Jalarmy Road & Lake Minneola Shores Roundabout

Stormwater Calculation Package

Exemption Statement for the Jalarmy Rd and Lake Minneola Shores Roundabout Project

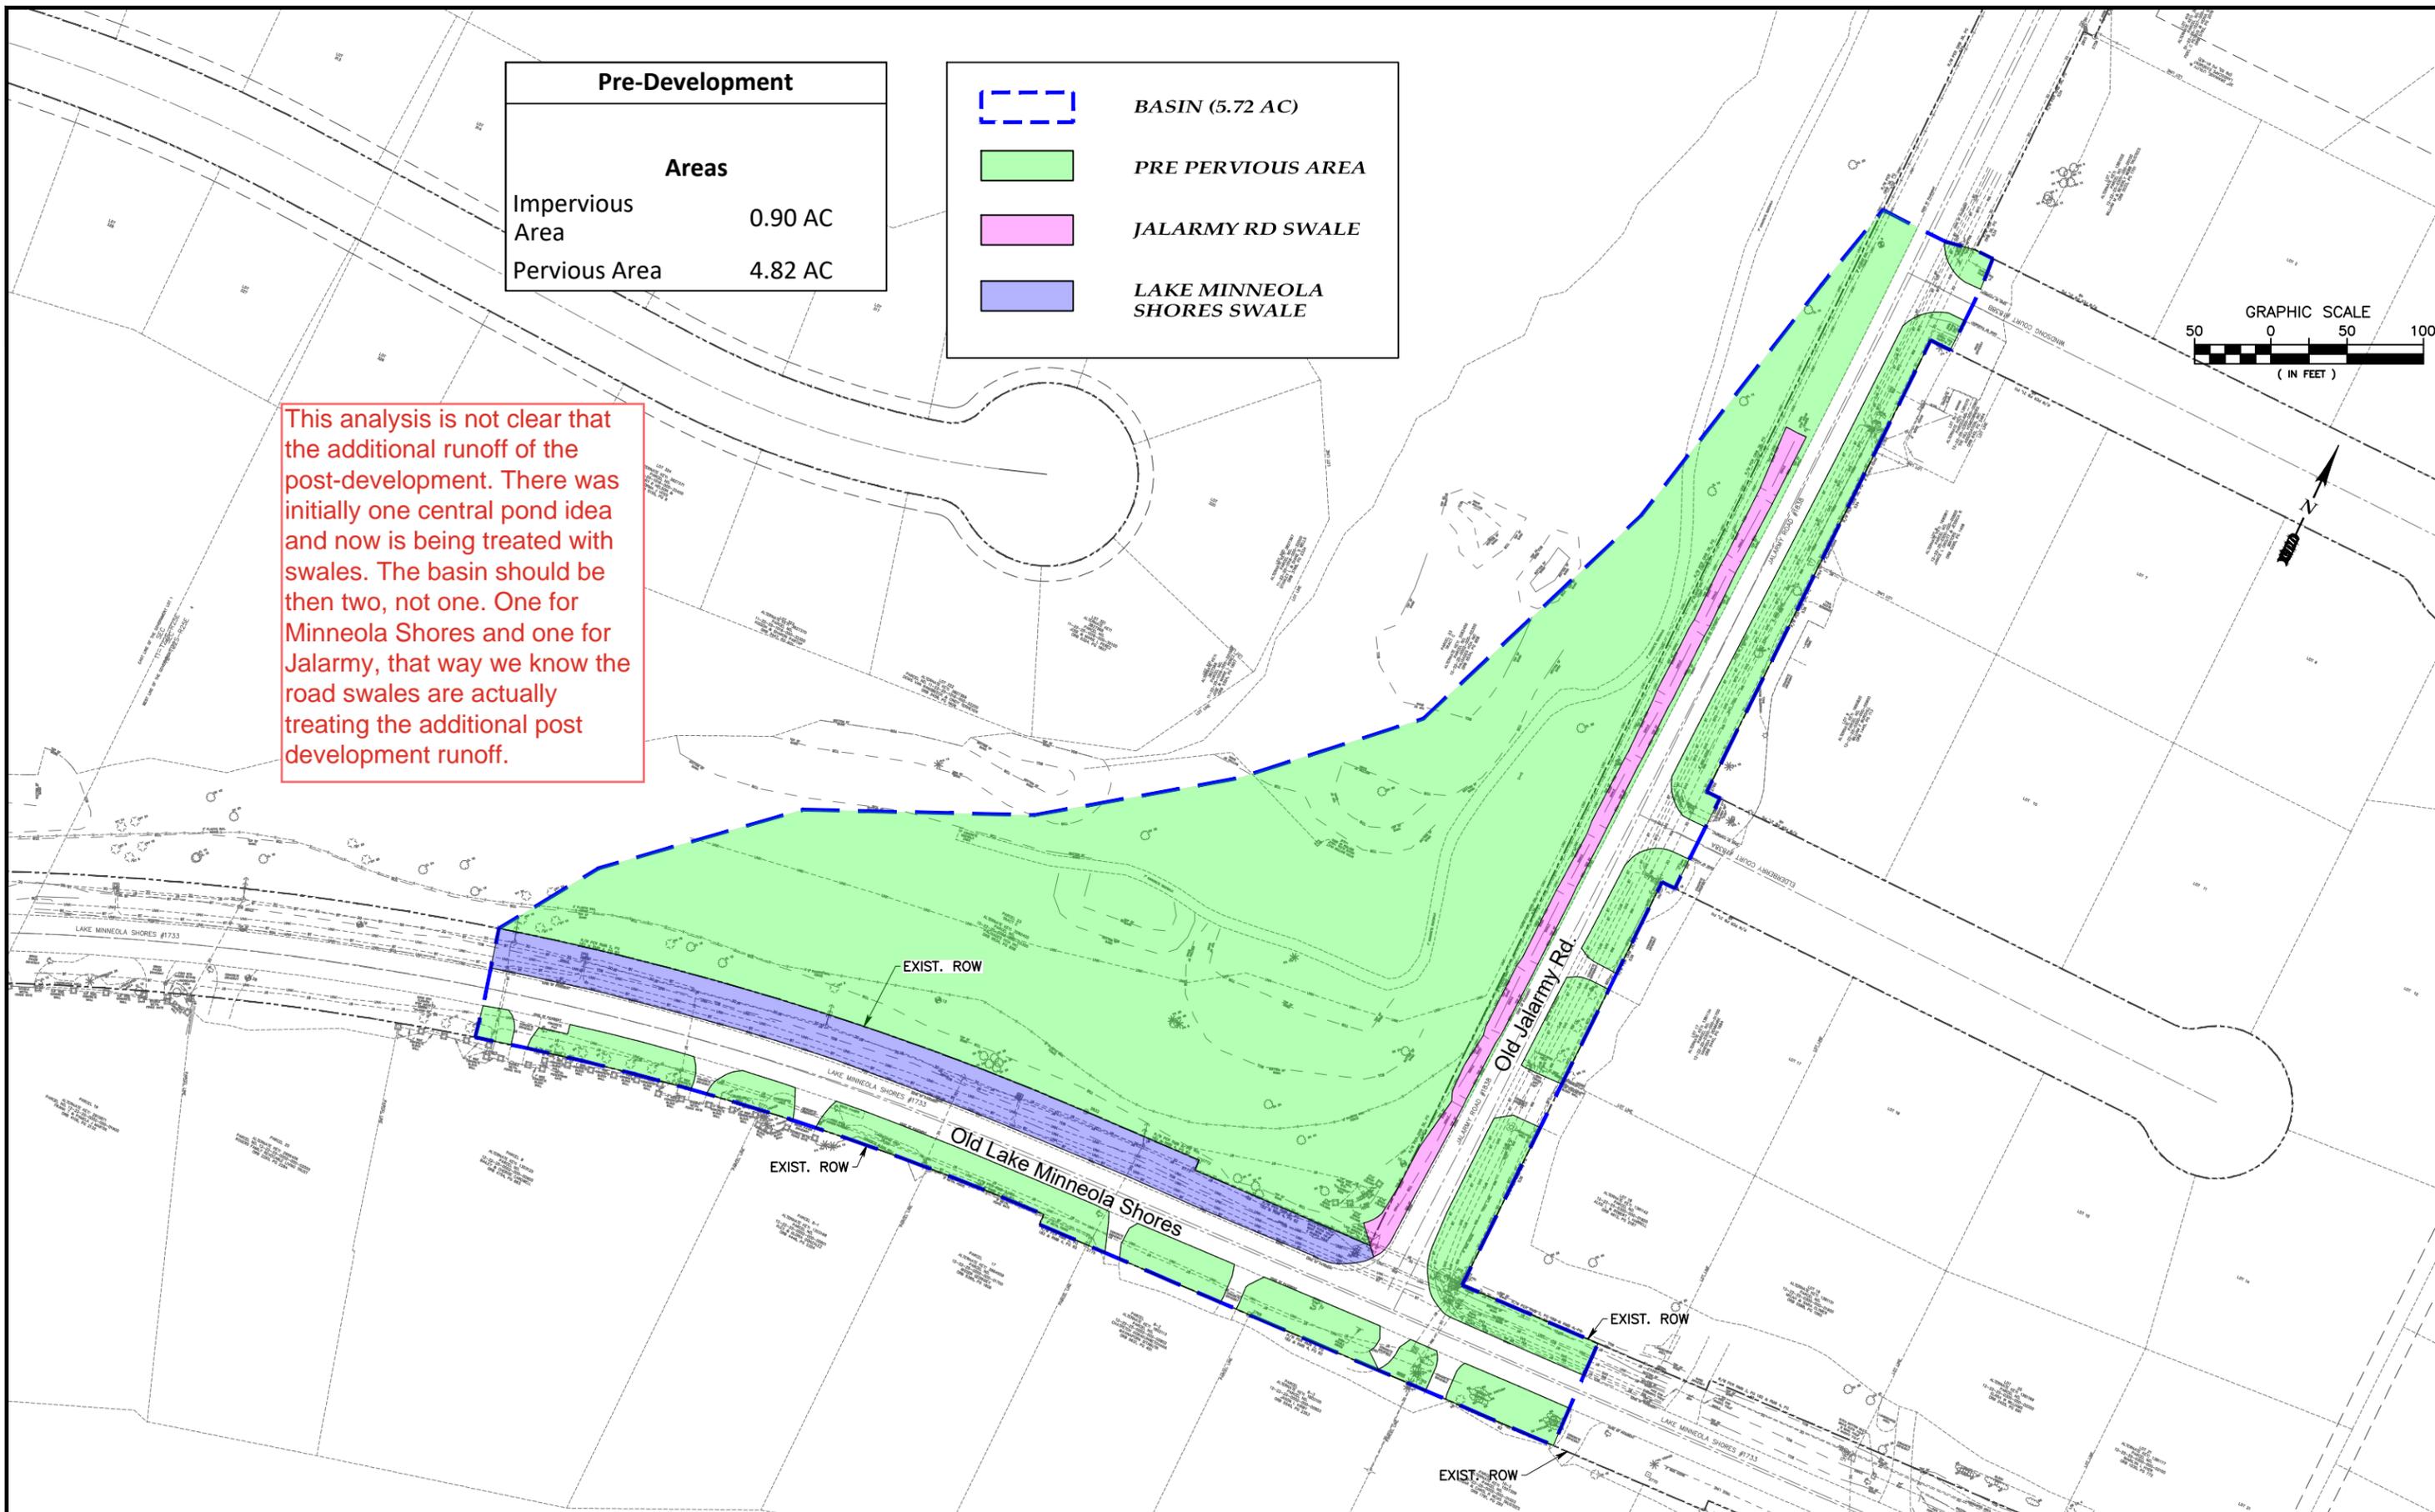
This analysis is not clear that the additional runoff of the post-development. There was initially one central pond idea and now is being treated with swales. The basin should be then two, not one. One for Minneola Shores and one for Jalarmy, that way we know the road swales are actually treating the additional post development runoff.

Post-Development Basin Map

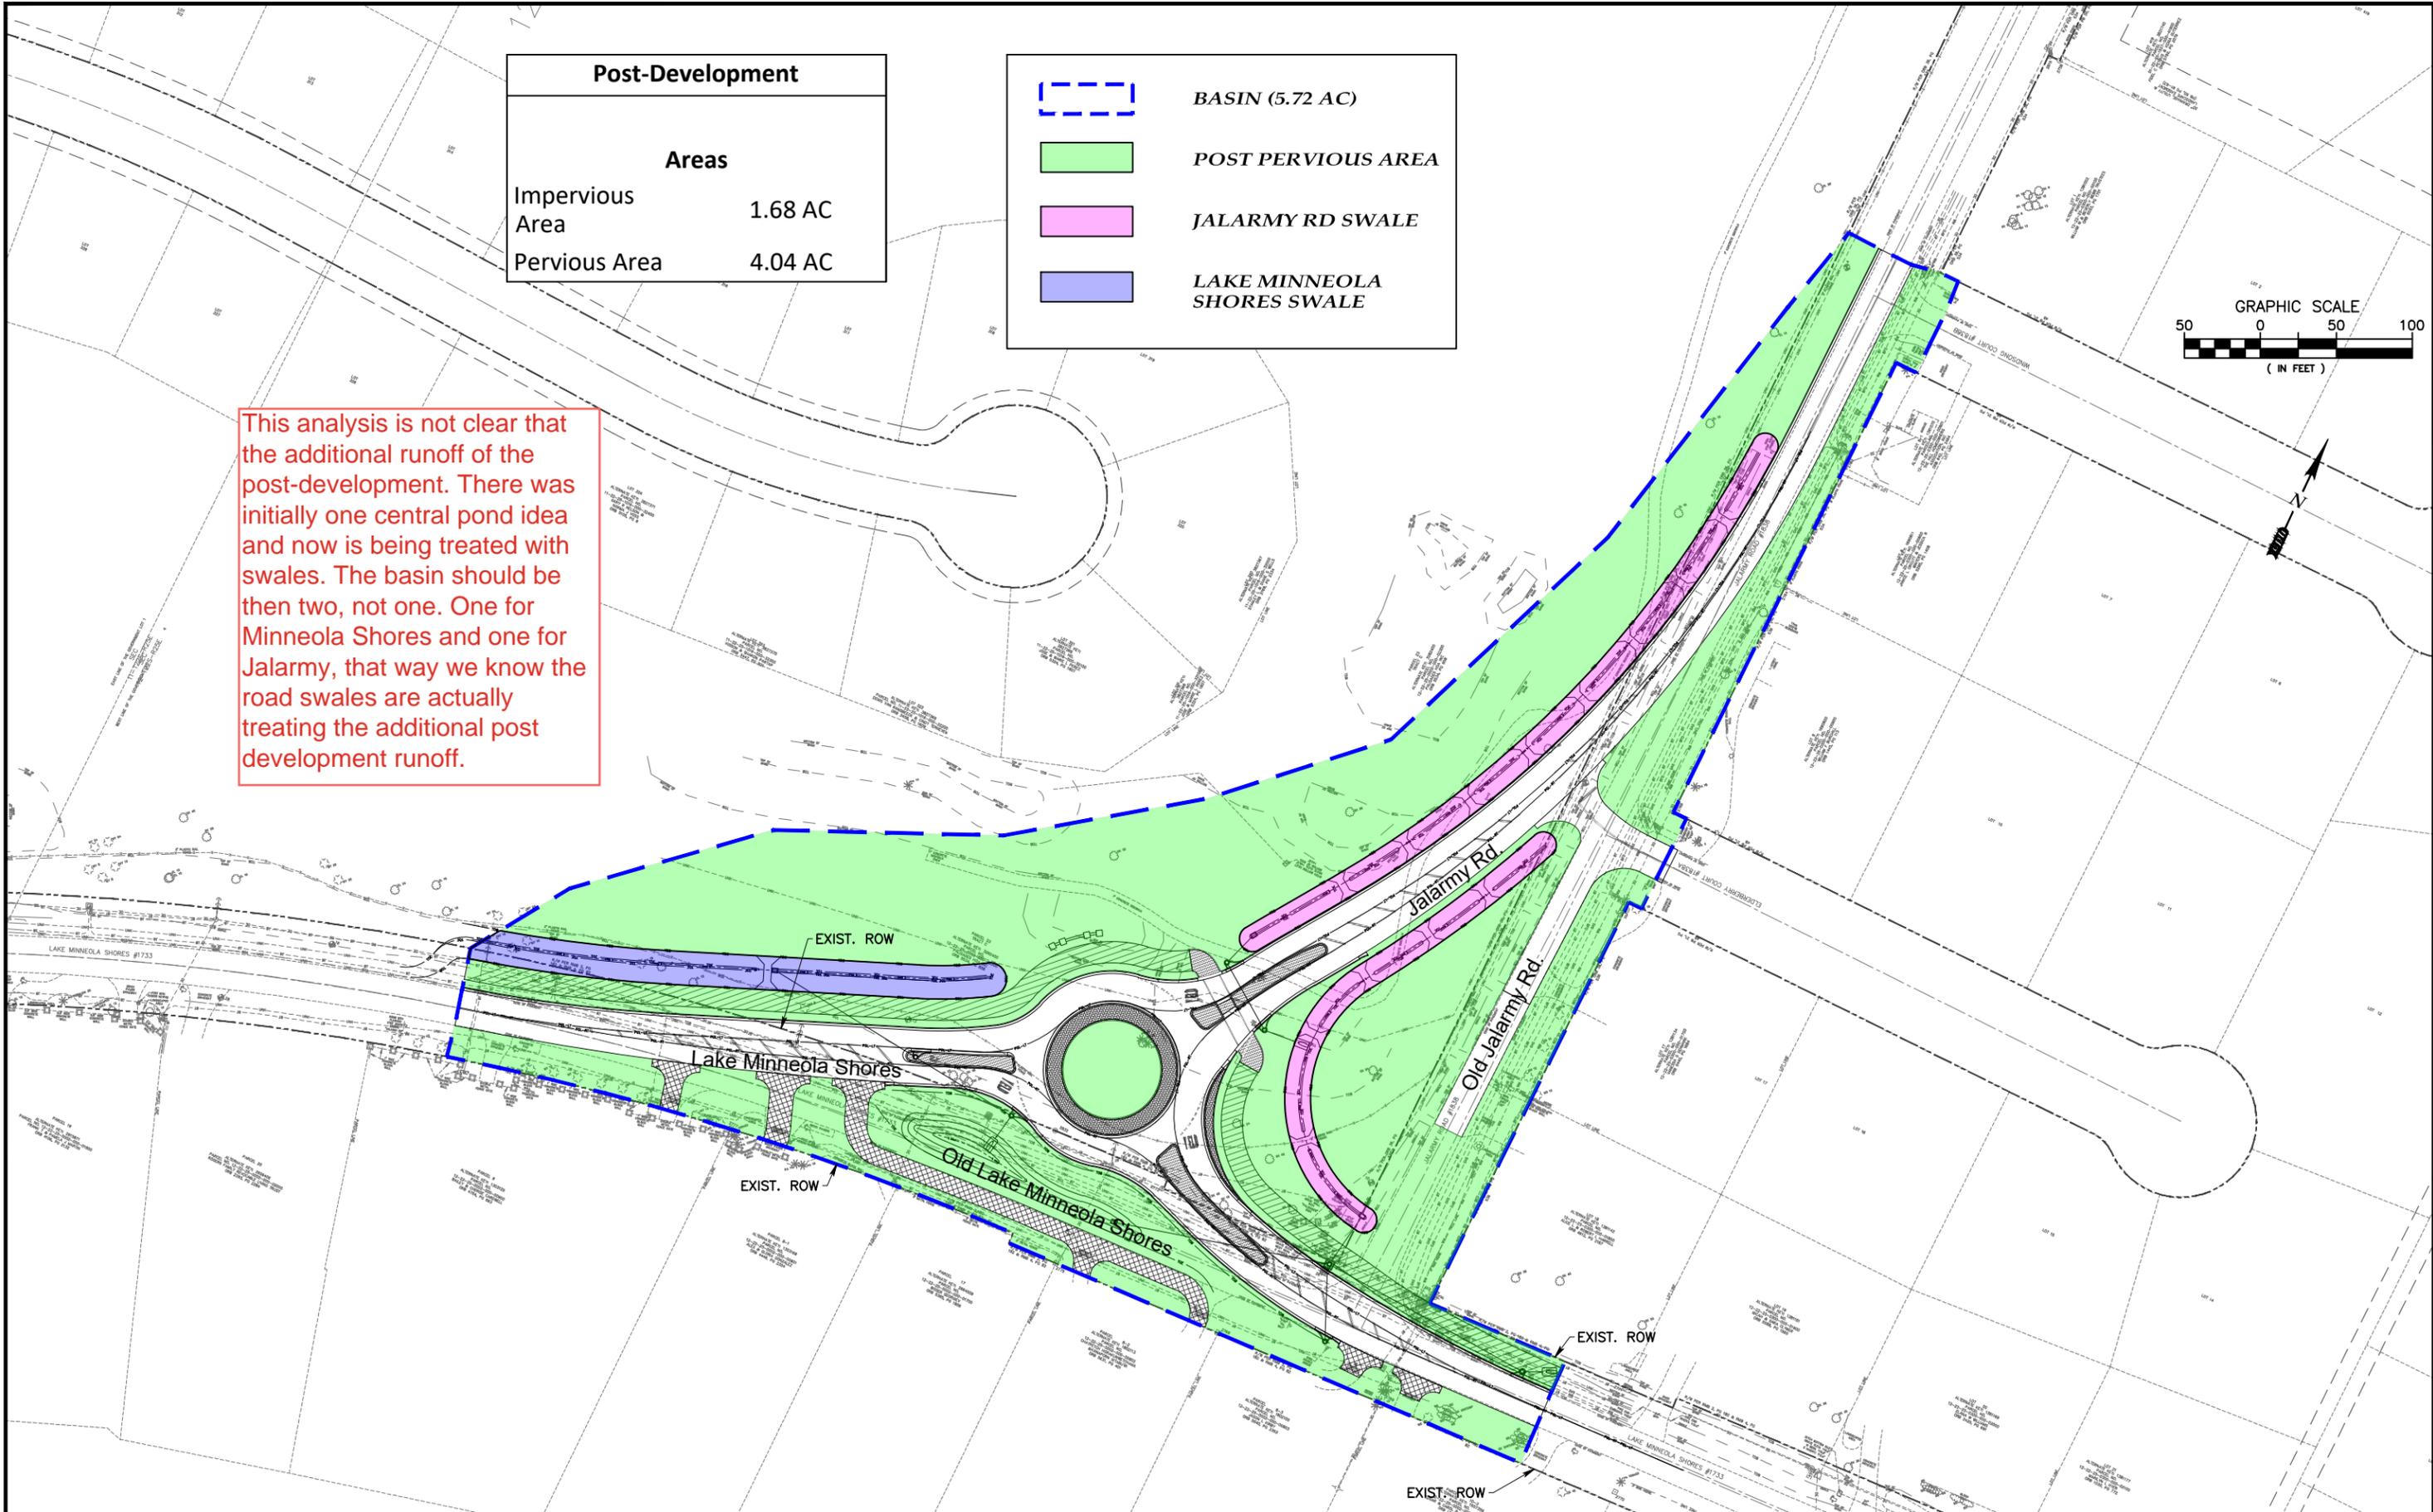
This analysis is not clear that the additional runoff of the post-development. There was initially one central pond idea and now is being treated with swales. The basin should be then two, not one. One for Minneola Shores and one for Jalarmy, that way we know the road swales are actually treating the additional post development runoff.
